CALIFORNIA COASTAL COMMISSION

REGULAR CALENDAR
STAFF REPORT AND PRELIMINARY RECOMMENDATION

Application No.: 6-04-38

Description: Substantial demolition and reconstruction of a previously-conforming 1,779 sq.ft., two-level duplex resulting in a 2,135 sq.ft., three-level duplex including retention of a 3-ft. high concrete privacy wall that encroaches three feet into the public right-of-way (Ocean Front Walk) on a 2,213 oceanfront lot.

EXHIBIT NO. 3
APPLICATION NO.
6-04-38
Existing building footprint/topo
 California Coastal Commission

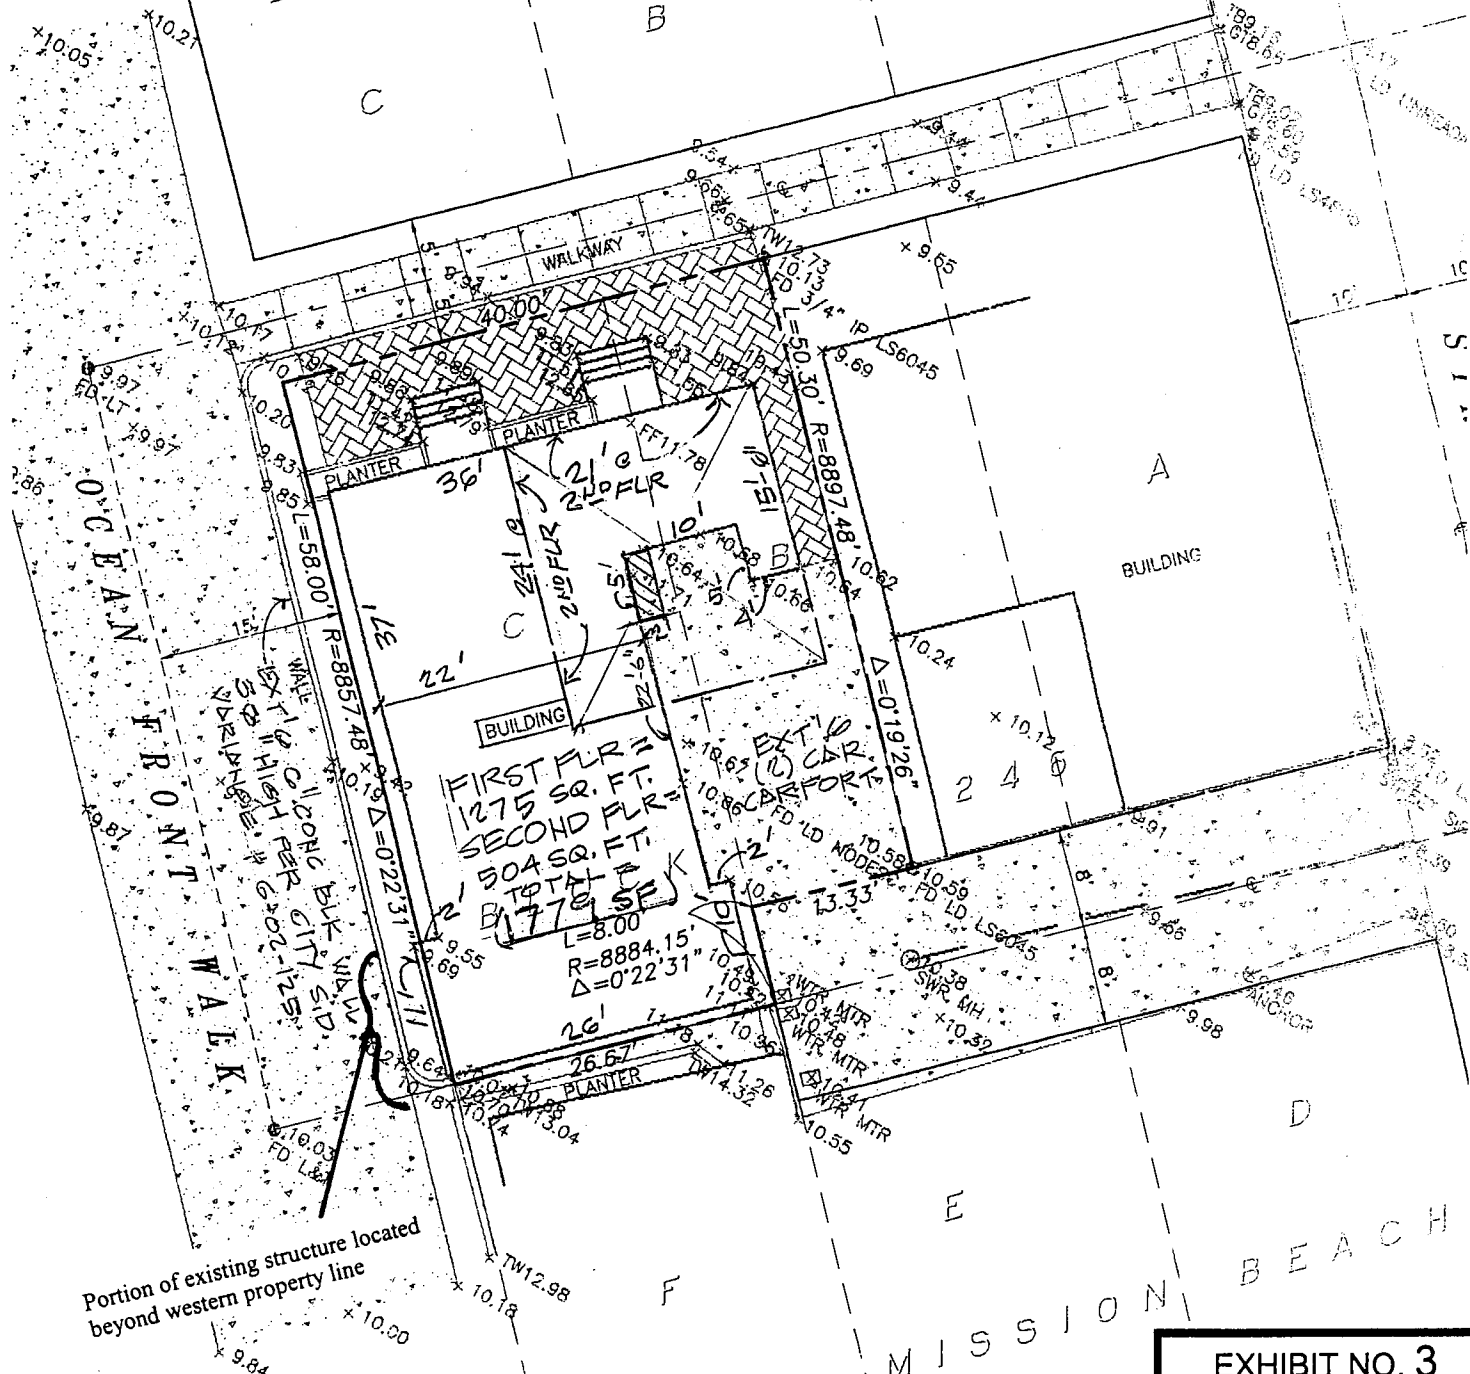
4. Existing Non-Conforming Structures. The duplex structure which exists on the property today is non-conforming with respect to required development setbacks from property lines. The existing residential structure extends to the western property line (with a small portion extending beyond the western property line into the public right-of-way of Ocean Front Walk – the public boardwalk and does not provide the 7 ft. building setback as required by local ordinances that are also part of the certified LCP (Mission Beach Planned District Ordinance).

The existing duplex and privacy wall do not conform with the certified LCP. The duplex is not sited at least 7 feet from the western property line.

Portion of existing structure located
beyond western property line

EXHIBIT NO. 4
APPLICATION NO.
6-04-38
Middle Level/First Floor

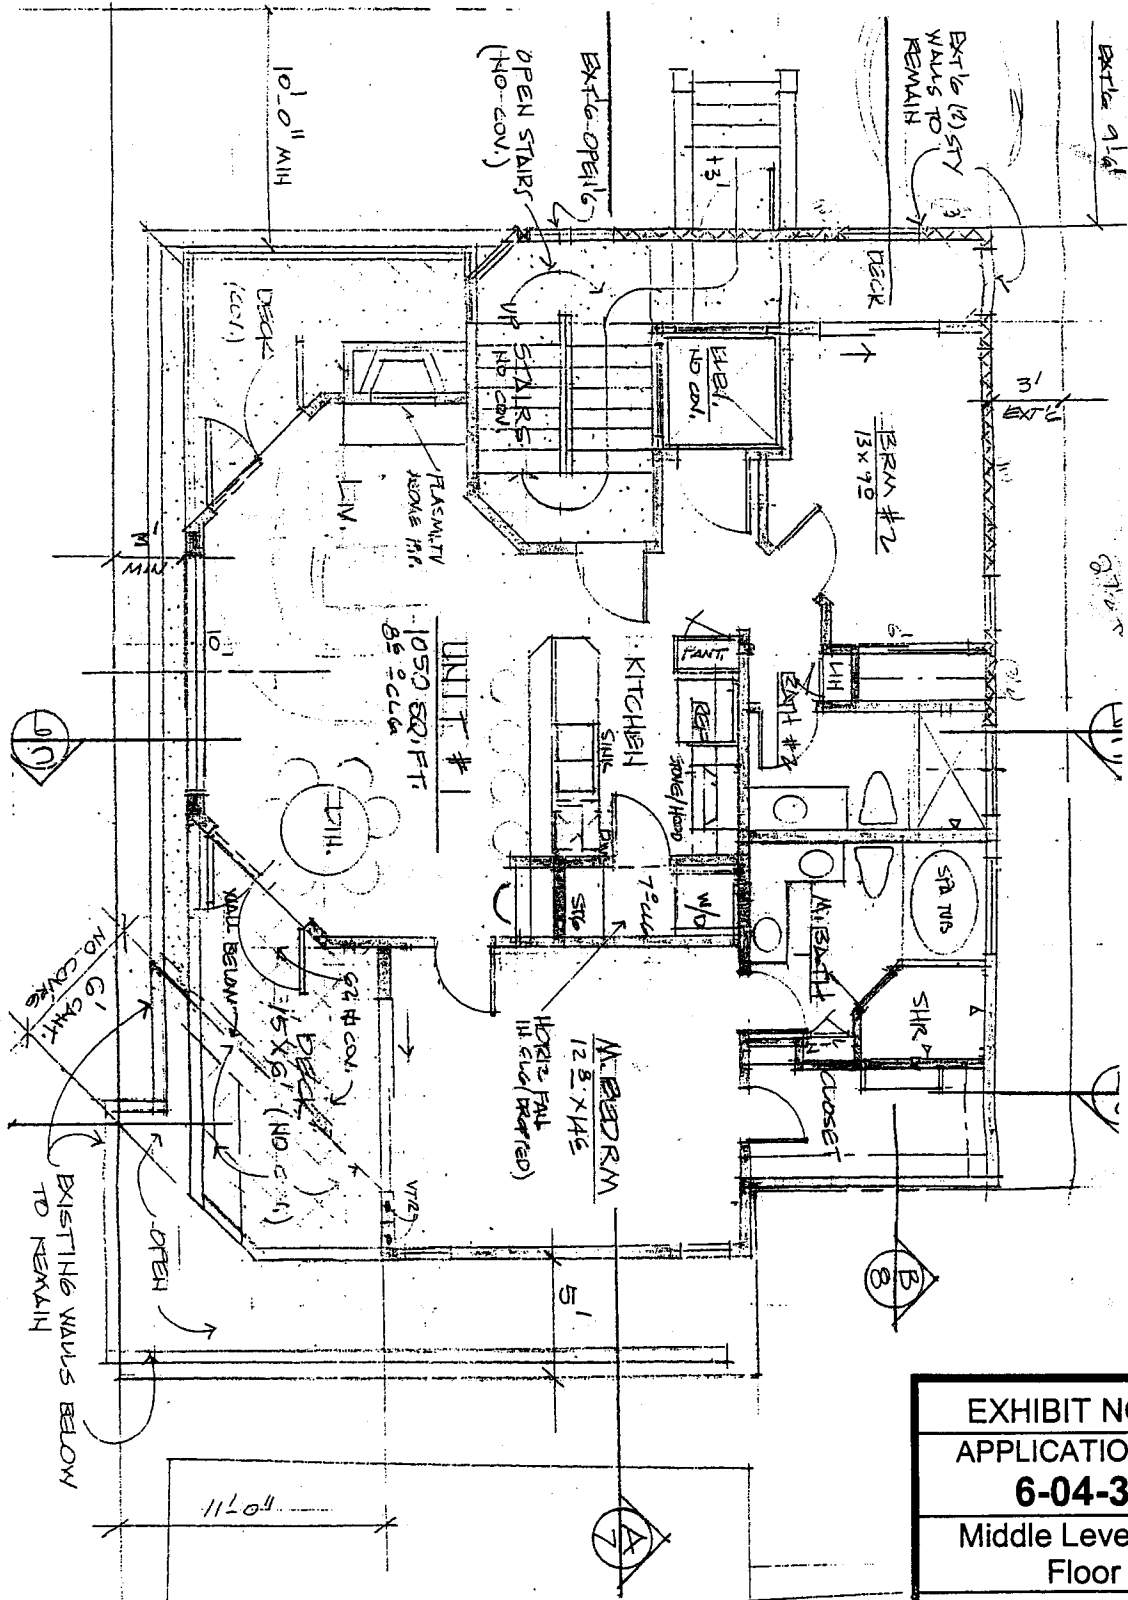
In this particular case, although the applicant describes the development as a "remodel and addition to a previously existing duplex...", the proposed development is actually the substantial demolition of an existing duplex and the construction of a new duplex. Although the applicant has submitted plans which attempt to demonstrate that more than 50% of the exterior walls will be retained, the plans are obscure and difficult to read. In any regard, it is clearly evident from the legend on the plans that the majority of the walls in the existing structure are being removed and that the only walls that will be left in

place are those walls that presently are non-conforming and are located within the building setback closest to the public boardwalk (ref. Exhibit Nos. 1 & 4). In addition, as part of the applicant's previous permit for the construction of the privacy wall, they obtained an Encroachment Removal Agreement from the City. The findings of that agreement state the following:

In this particular case, the plans submitted by the applicant indicate that approximately 56% of the exterior walls were being retained. However, the plans are unclear and, while Commission staff has asked for more detailed and "readable" demolition and floor plans, the applicant has refused to provide them. As such, although the Commission cannot be entirely certain that more than 50% of the exterior walls of the existing structure will be demolished, the best conclusion possible given the available evidence is that is the case.

Looking south along public boardwalk (Ocean Front Walk)

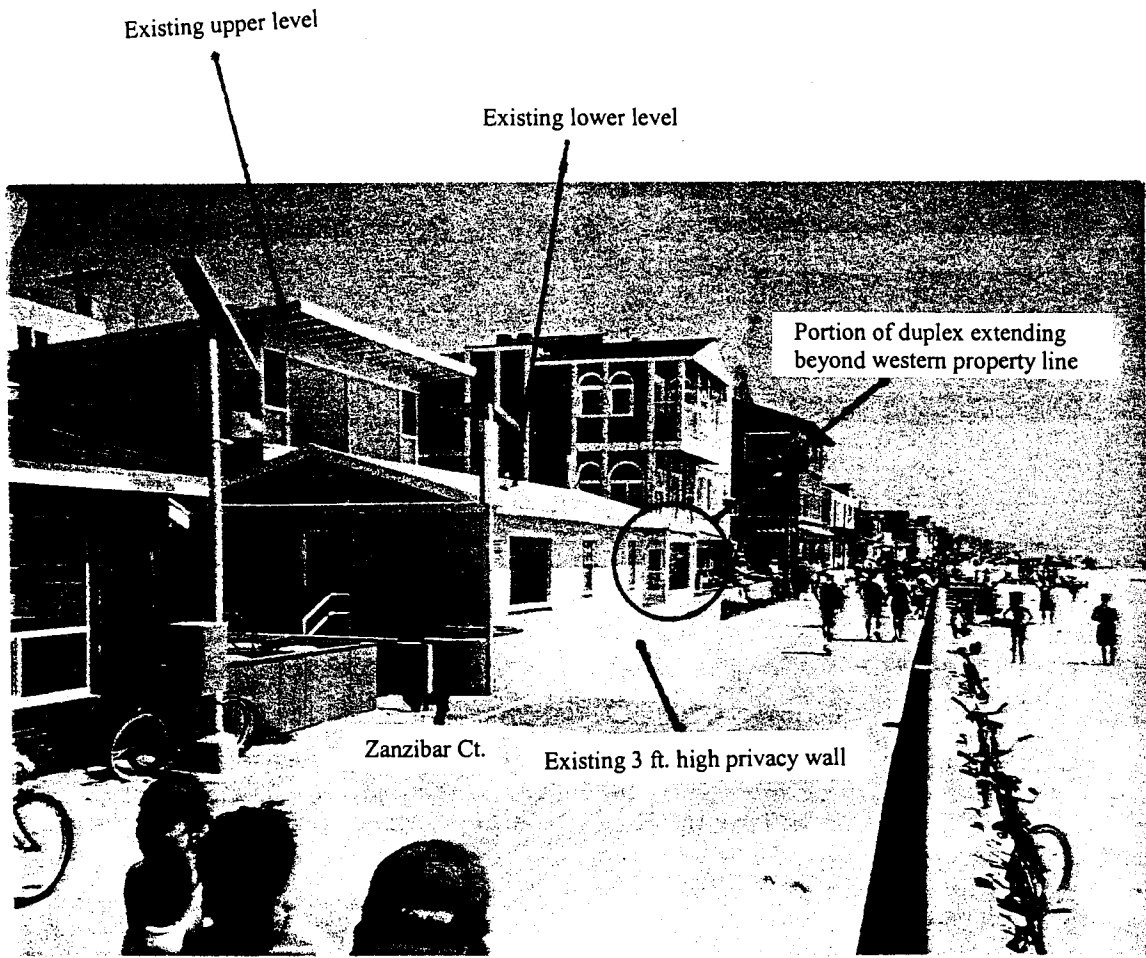
I have not seen the building plans. But the current building has part of the building on a zero lot line next to the boardwalk. It is the last ten feet of the building. This part of the structure should not be allowed to stay if there is a major renovation of this building.

The city allowed the homeowners to build ~~th~~ a new wall three feet into the public right away to protect the building in case of wave destruction. As you can see the building north and south wall are back the three feet. Also the remaining house is only 18' from the

If the owner are doing major work on the second floor, they will not be allowed to build using the current 0 yard setback or 18 inch setback

Thus they will have major work on the first floor for support on the second or third floor. The building should be move back three feet from property line, so the current wall can be move

back three feet. Bring back the ^{total} boardwalk access, the city backed down by allowing the homeowners to come into the boardwalk right-of-way. They will never take that wall down if the Coastal Commission doesn't enforce the right of way.

You can tell something is wrong, when the city allowed the new wall to be three feet into right of way even though most of the wall is back 18 inches. Thus they have a four and half space. Politics, the planning group voted ^(2 years ago) unanimous that if most of the building is not on the zero lot line the ^{new} wall should not be into three foot setback except for portion that is zero. The city sent out Terri Williams and another person. They ignored our vote.
